KMR.CDD.MmQ.1916.03

ORDERS UNDER SECTION 96 (2) OF ACT, III OF 1901

With reference to his application, dated 2nd May 1916.
 Messrs Nance & Kanyo sons of Kaji is informed
 that the plan submitted by him for building rooms on 3rd floor
 of building on plot No. 85, Survey Sheet C1,
 situate in Kasim Street, Machi Meani
 Quarter, is approved, and permission to build in accordance therewith is
 Granted. The building to be erected subject to the Bye-laws and Rules of the
 Municipality.

PLAN SHOWING PROPOSED ROOMS ON 3RD FLOOR ON HOUSE
ON PLOT NO 85 SHEET C.1 MUCHEE MEANEE QR
SCALE: 8FT=1"

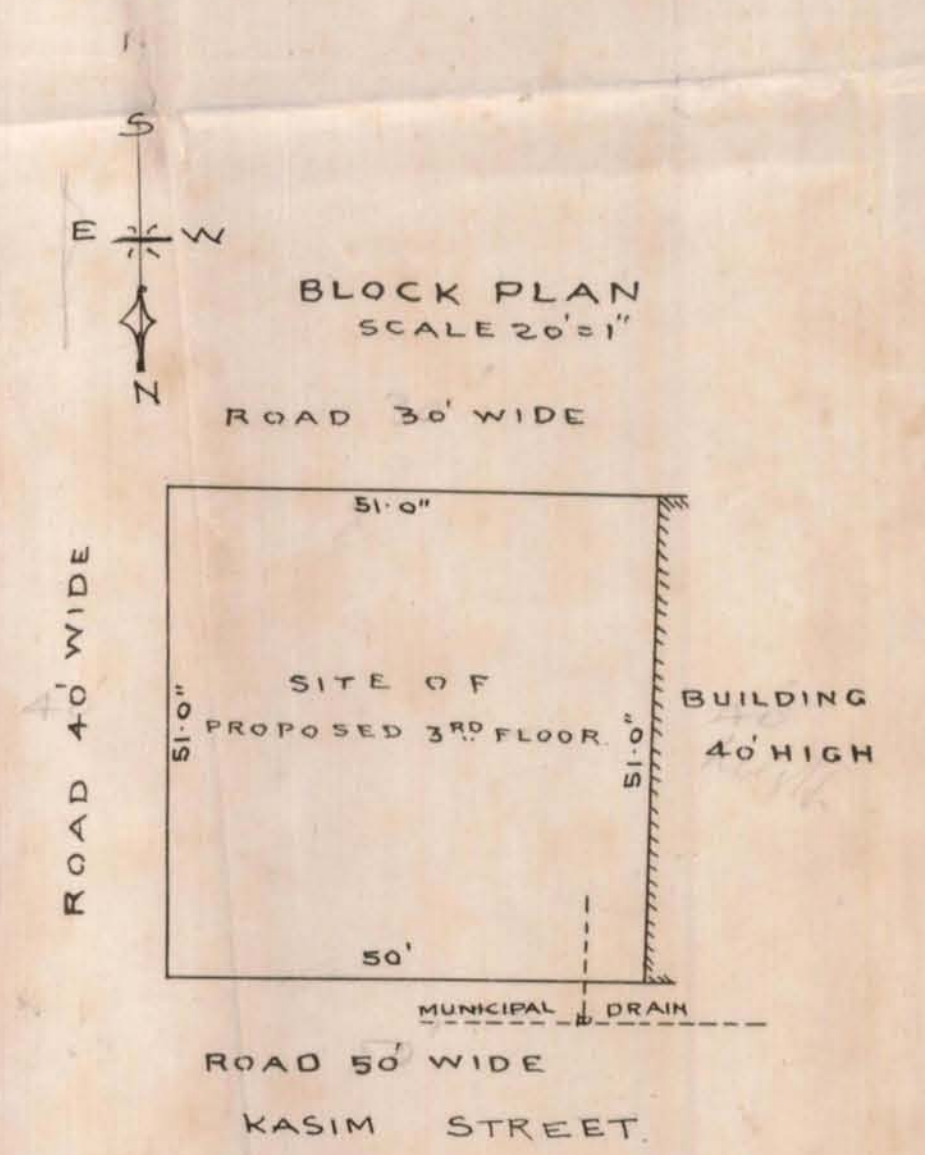
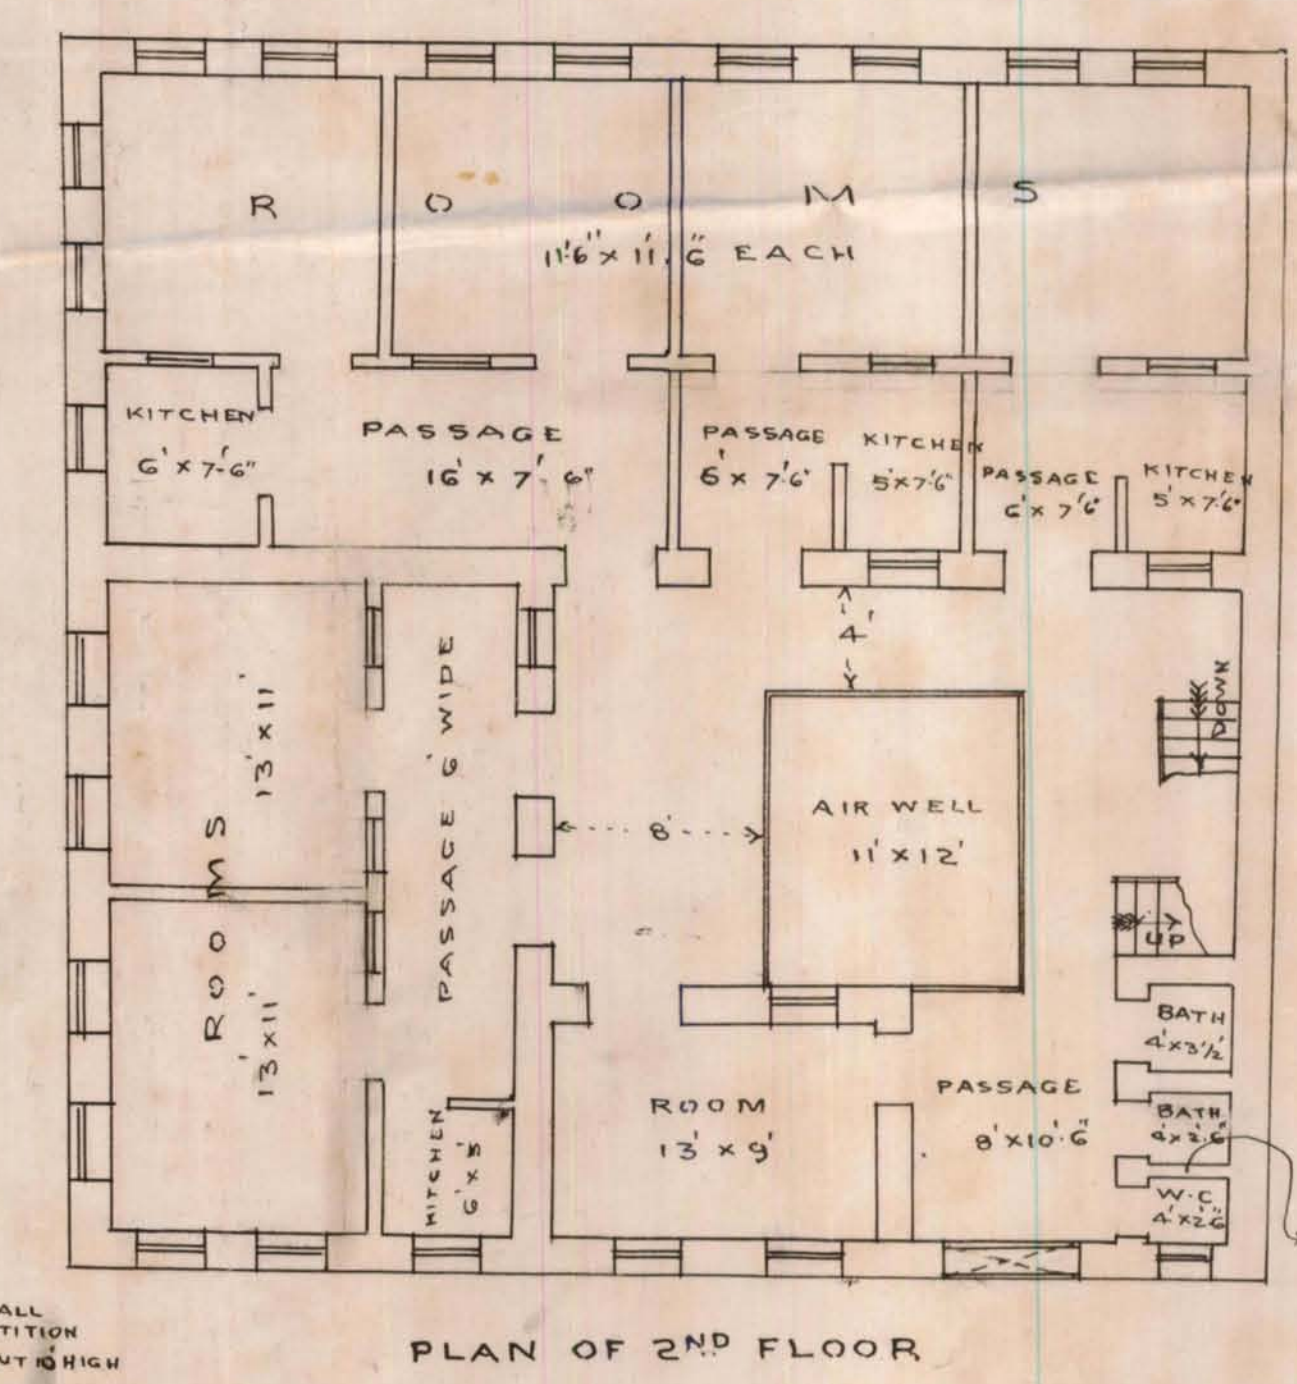
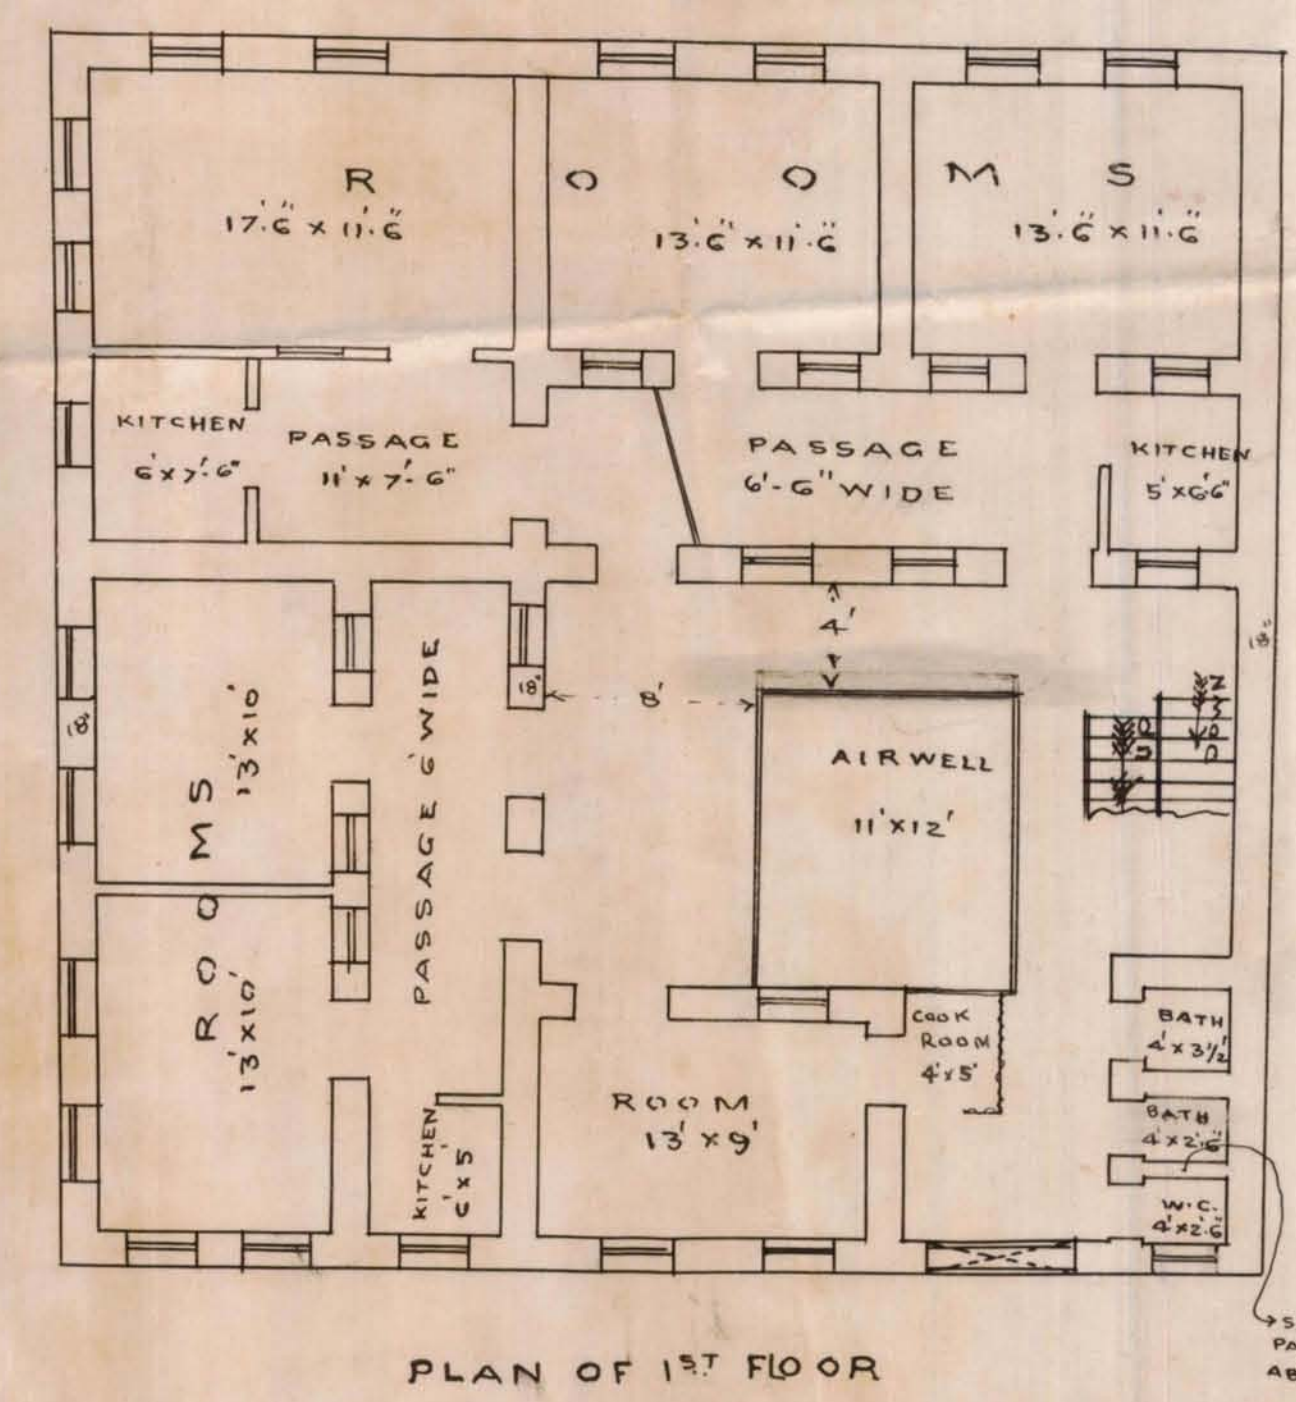
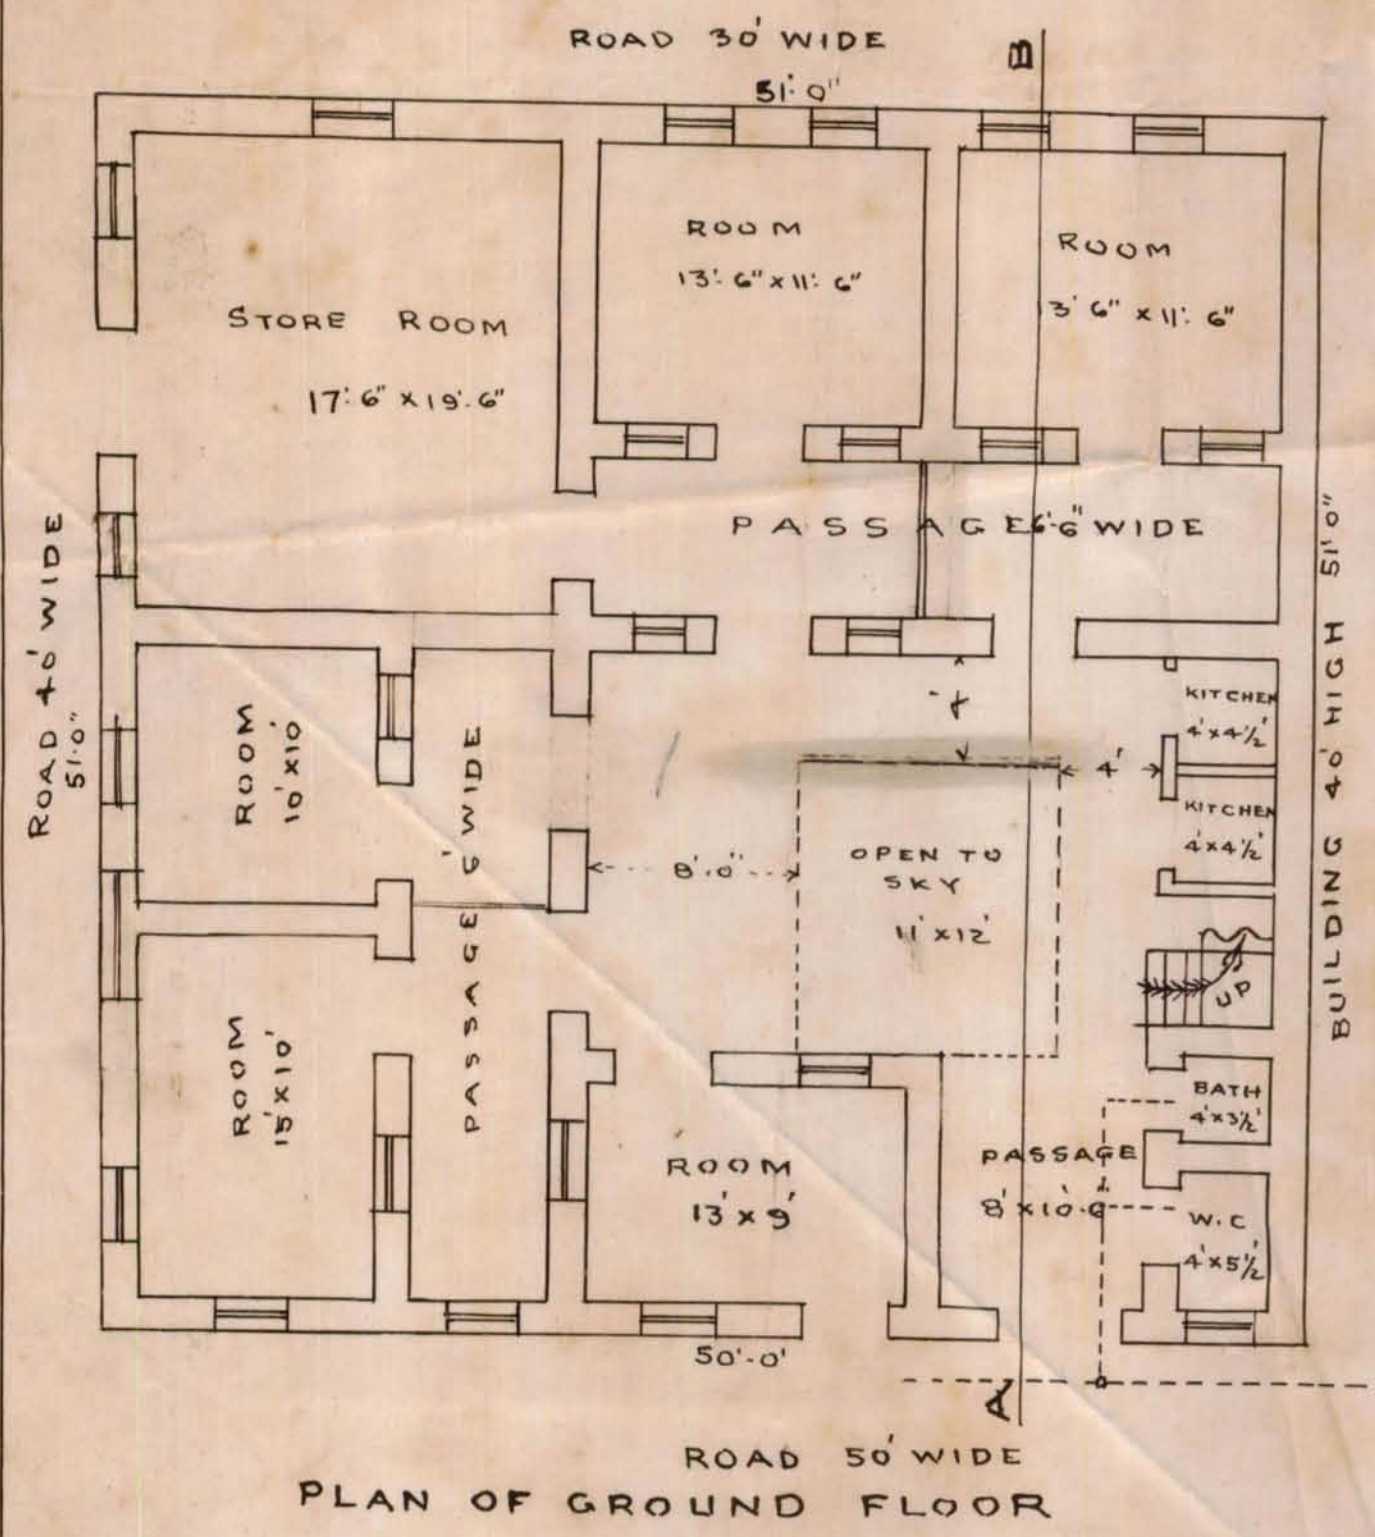
with the C.D.'s consent. On the east side where the road is shown

40 ft wide on the plan where as the same is only 30 ft in the S. Street. Respect

report that there is no objection to the additional story to be built, but there is already too much on the plot. Request your order
